APPLICATION NO.	FILING DATE	FIRST NAMED INVENTOR	ATTORNEY DOCKET NO.	CONFIRMATION NO.
09/774,847	01/31/2001	Harald Krondorfer	1466	6258
	7590 05/18/2007 RIKER & STENBY	EXAMINER		
103 East Neck Road			WEEKS, GLORIA R	
Huntington, NY	(11743		ART UNIT	PAPER NUMBER
·			3721	
	•			
			MAIL DATE	DELIVERY MODE
•			05/18/2007	PAPER

Application/Control Number: 09/774,847

1. In view of the Appeal Brief filed on February 2, 2007, PROSECUTION IS HEREBY REOPENED. A new grounds for rejection is set forth below.

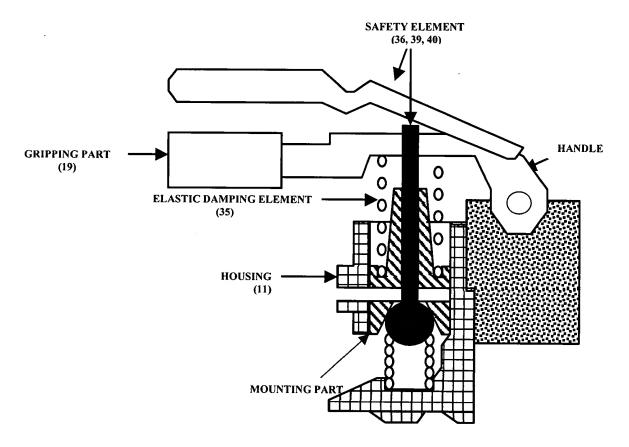
Regarding claims 11, 14-17, 19, 20 and 21, Johansson et al. discloses a hand power tool comprising: a housing 11; at least one handle having at least one gripping part 19; a mounting part (supports 40 within 35; see illustration below); at least one elastic, vibration damping

element 35 mounted on the mounting part, the at least one gripping part 19 being mounted on the housing 11 through the elastic element 35 and through the mounting part; at least one movable rigid 36, 40 safety element and non-rigid safety element 39 through which the gripping part 19 is connected with the mounting part, the safety element 36, 39, 40 being movable relative to the gripping part 19 in at least a tilting direction 36 and a longitudinal direction 39, 40 during a predetermined operation relative to the gripping part 13 to avoid a passage of vibration through the safety element 36, 39, 40, wherein the elastic element 35 surrounds the safety element 40.

With respect to claim 24, Johansson et al. discloses, a hand power tool comprising: a housing 11; at least one handle having at least one gripping part 19; at least one elastic, vibration damping element 35; a mounting part (supports 40 within 35) on the elastic element (35; see

illustration above); the at least one gripping part 19 being mounted on the housing 11 through the elastic element 35 and through the mounting part; at least one movable safety element 36.

In reference to claim 25, Johansson et al. discloses a hand power tool comprising: a housing 11; at least one handle having at least one gripping part 19; at least one elastic, vibration damping element 35; a mounting part (supports 40 within 35) on the elastic element (35; see illustration above); the at least one gripping part 19 being mounted on the housing 11 through the elastic element 35 and through the mounting part; at least one movable safety element 36.

Regarding claim 26, Johansson et al. discloses a hand power tool comprising: a housing 11; at least one handle having at least one gripping part 19; a mounting part (supports 40 within 35; see illustration above); at least one elastic, vibration damping element 35 mounted on the mounting part, the at least one gripping part 1) being mounted on the housing 11 through the elastic element 35 and through the mounting part; at least one movable and non-rigid safety element 36, 40 through which the gripping part 19 is connected with the mounting part, the safety element 36, 39, 40 being movable relative to the mounting part in at least a tilting direction 36 and a longitudinal direction 39, 40 during a predetermined operation relative to the gripping part 19 to avoid a passage of vibration through the safety element 36, 39, 40, wherein the elastic element 35 surrounds the safety element 40.

7. In reference to claims 11, 24 and 25, Applicant has argued that Johansson et al. fails to disclose the gripping part 19 mounted on the housing 11 via the mounting part as illustrated above and interpreted by Examiner, rather the gripping part 19 is mounted to the housing by way of the bolt 32. Examiner agrees that bolt 32 mounts the gripping part 19 to the housing 11, however, the mounting part as identified by examiner, also mounts the gripping part 19 to the housing through the elastic member 35. Examiner has broadly interpreted the term "mounting" to be defined as the act of placing an object upon another object. Furthermore, Examiner has broadly interpreted the term "connected" to be defined as joining or bringing together at least two objects to form a continuous unit.<sup>2</sup>
